DESIGN ADVISORY BOARD Tuesday, September 23, 2014 Conference Room 12, City Hall, Burlington, VT AGENDA

To: The Design Advisory Board
From: Mary O'Neil, AICP, Senior Planner *mo*
RE: ZP 15-0079CA
Date: September 23, 2014

To: The Design Advisory Board
From: Mary O'Neil, AICP, Senior Planner
RE: ZP 15-0254CA; 434-436 South Winooski Avenue
Date: September 23, 2014

1 North Elevation

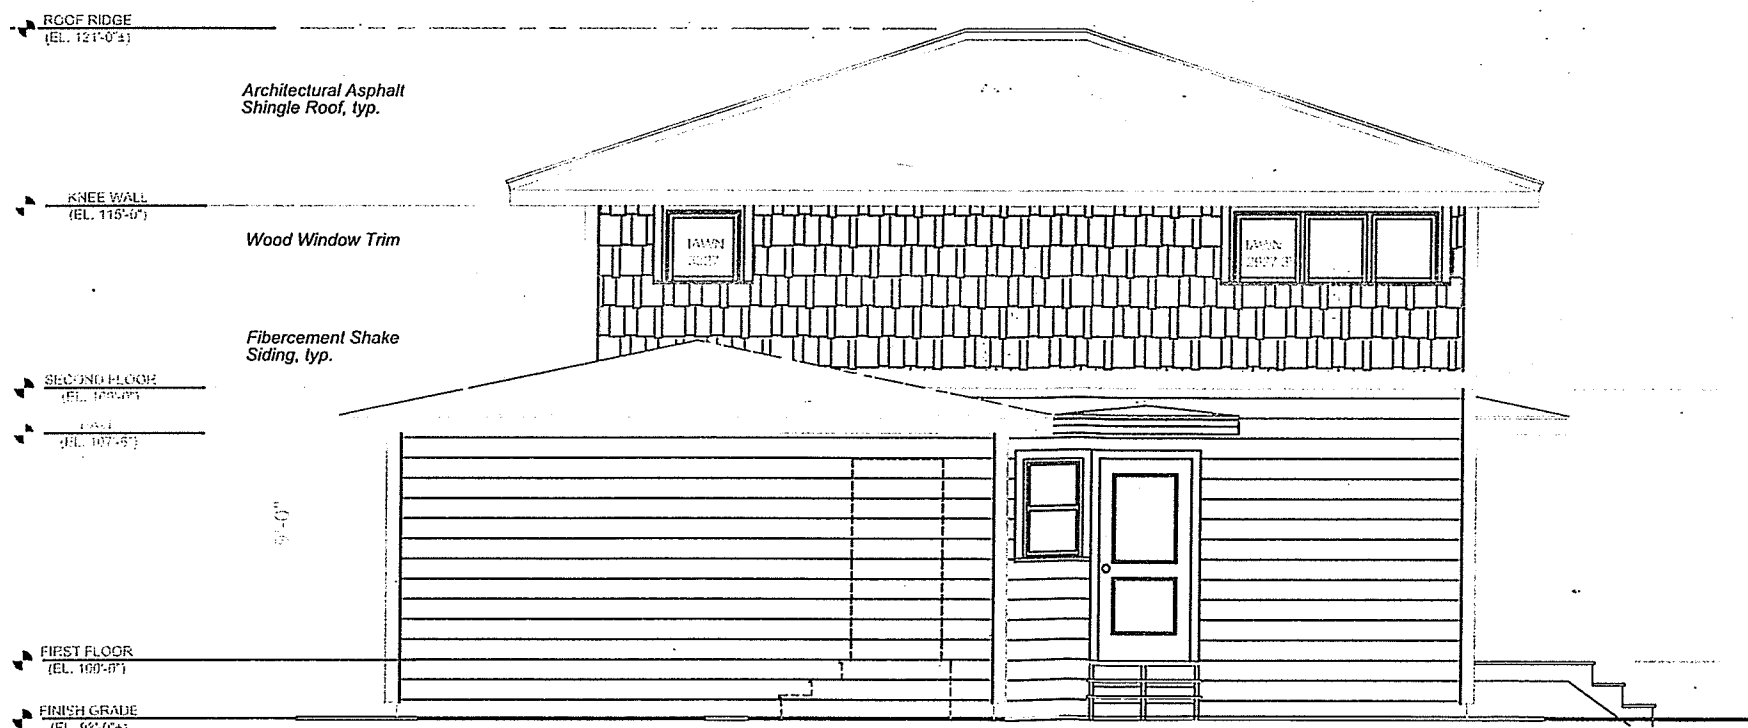
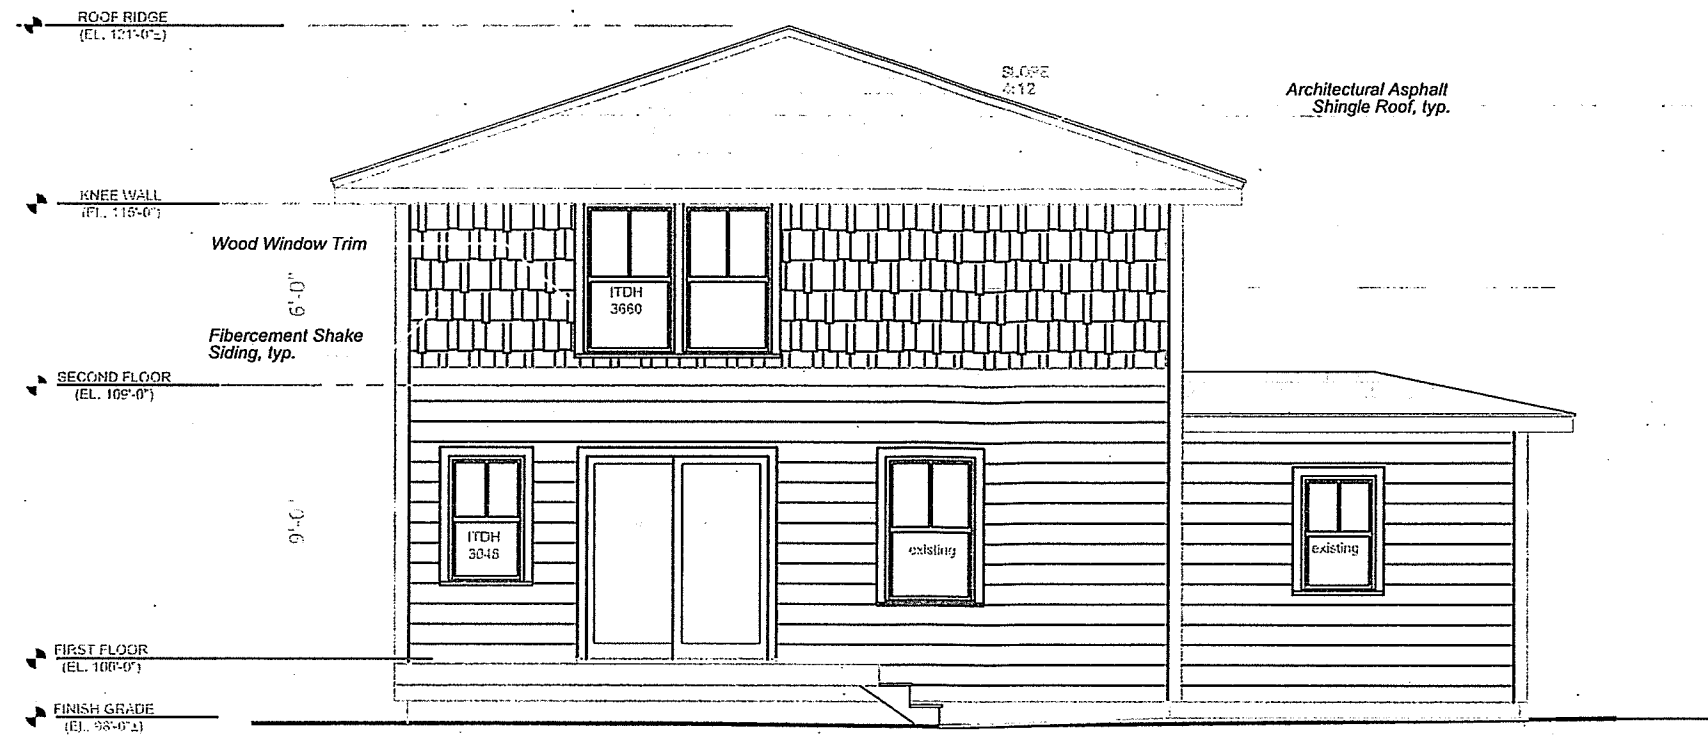
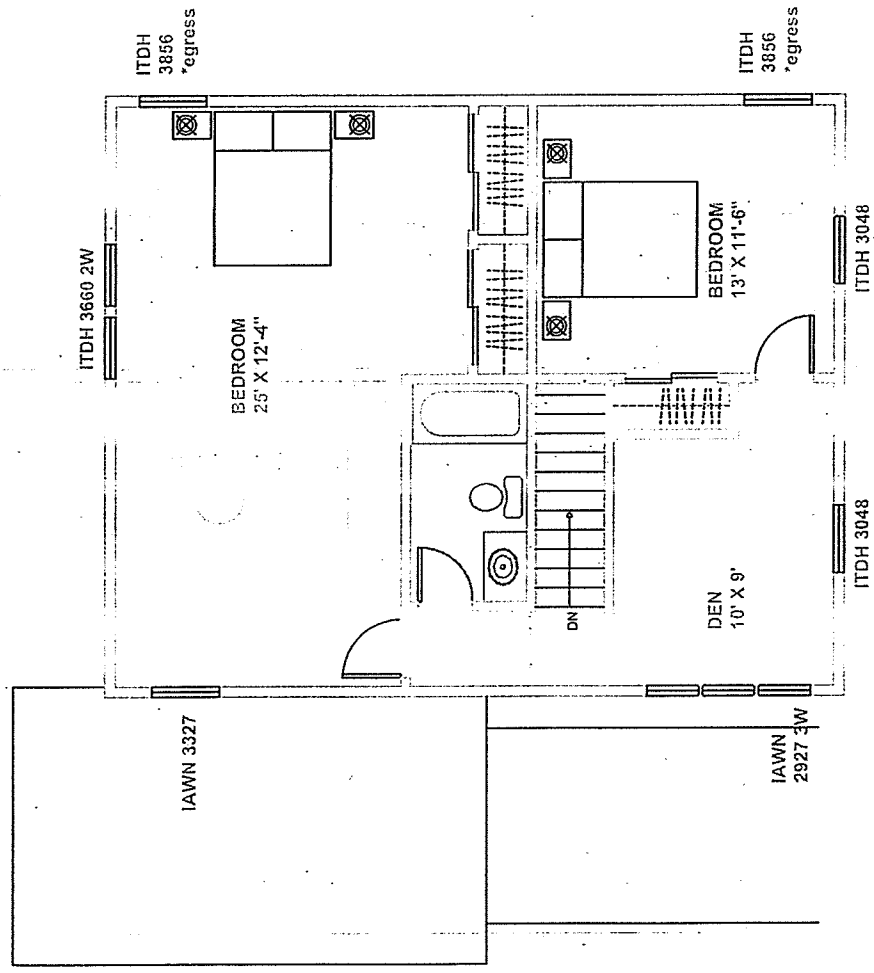
Revised plans illustrate the reconfiguration of front 2nd floor windows, reducing their size and height. The bow window is retained. The porch roof is now a hip roof and the plans define the siding change to shingle on the 2nd floor.

The disparity lies in the complete elimination of the first floor eave line, and expansion of the 2nd floor to fit squarely over the first floor. Therefore, the first and 6th recommendation relating to the relationship between the first floor eave and 2nd floor is not reflected. The floor plan reflects the expanded 2nd story space.

- Enlarge 2nd floor eaves to match depth of 1st floor eaves.
- Reconfigure front 2nd floor windows reducing their size and height
- Retain bow window
- Eliminate the gable porch roof – shed okay.
- Second floor siding change to shingle is acceptable.
- 2nd floor fascia should be the same as first floor fascia.

L2.0

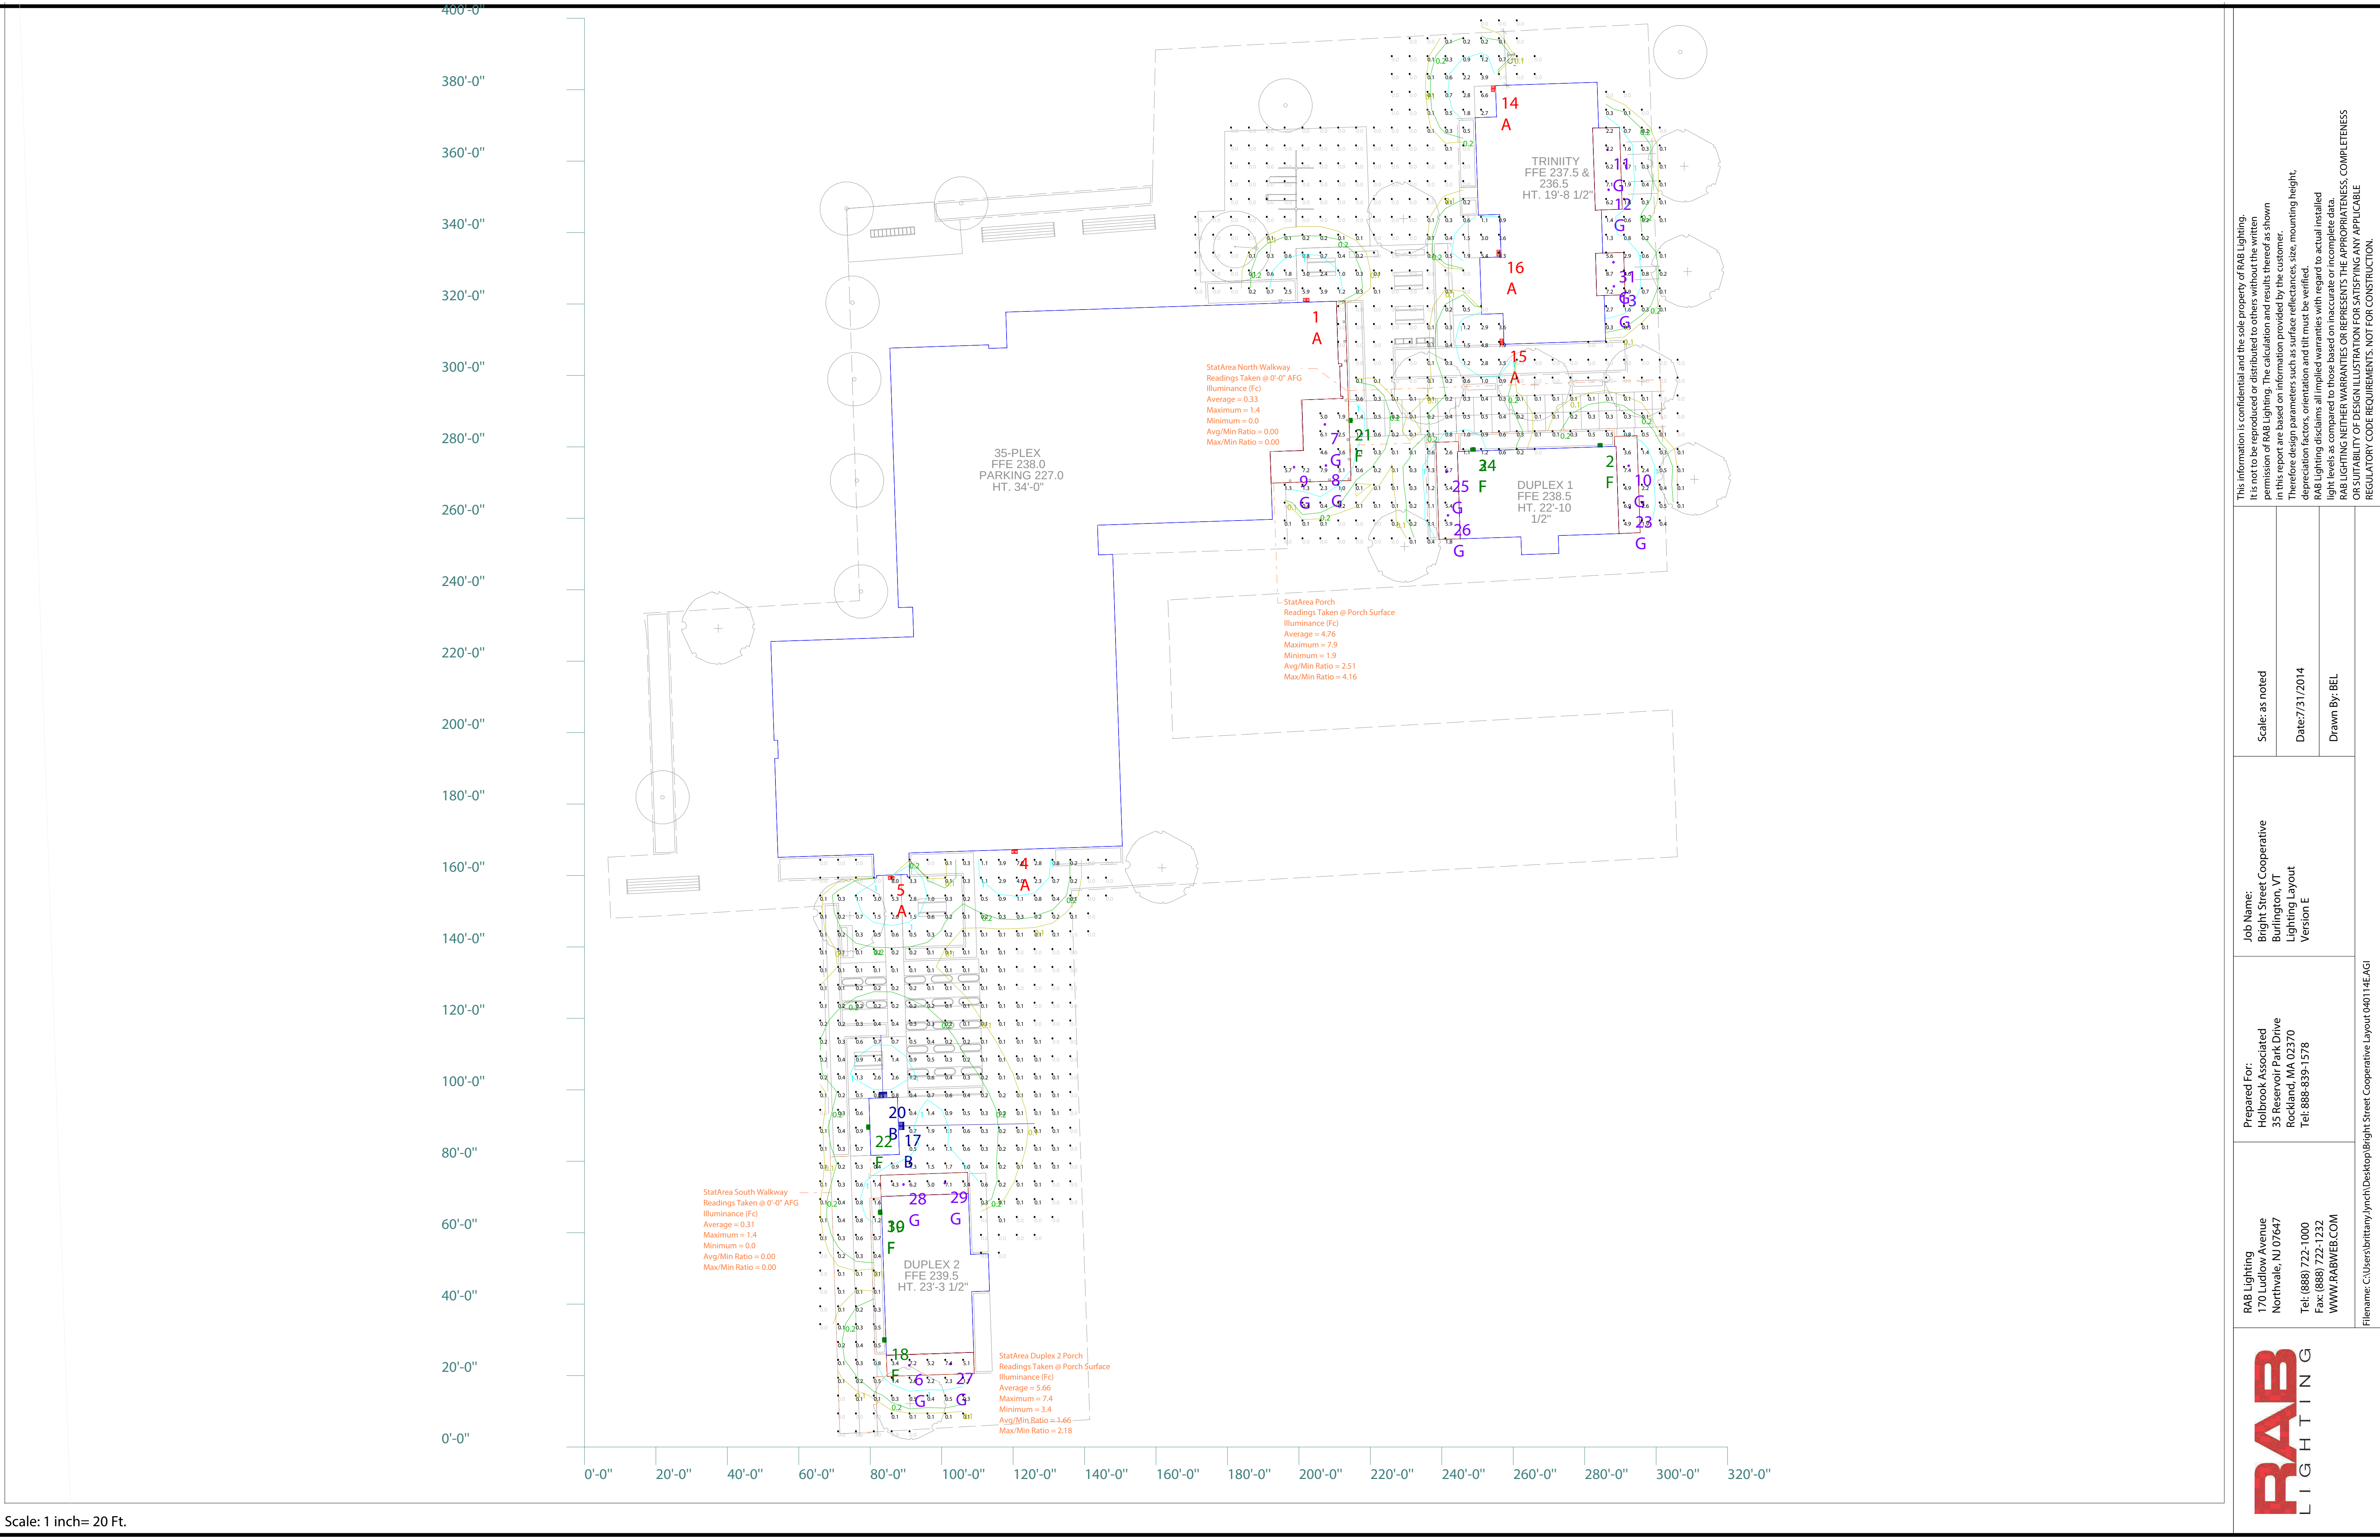
Exterior bicycle parking is illustrated on plan L2.0. The original plan defined 12 exterior bike parking spaces, and 11 interior. Revised plans add an additional 5 spaces, with a likelihood to increase that number. Interior bicycle parking is shown (behind the elevator) with 12 spaces identified, and on the parking level (plan 5.3) providing 16 spaces in the northwest corner.

The garden beds, patios, and walkways accessed from the Archibald Street sidewalk will provide pleasant grounds for resident enjoyment and passive activity. Several clotheslines and play areas are also identified on the plan (See L2.0.) Much opportunity is afforded for residential pleasure on the grounds of the newly developed site.
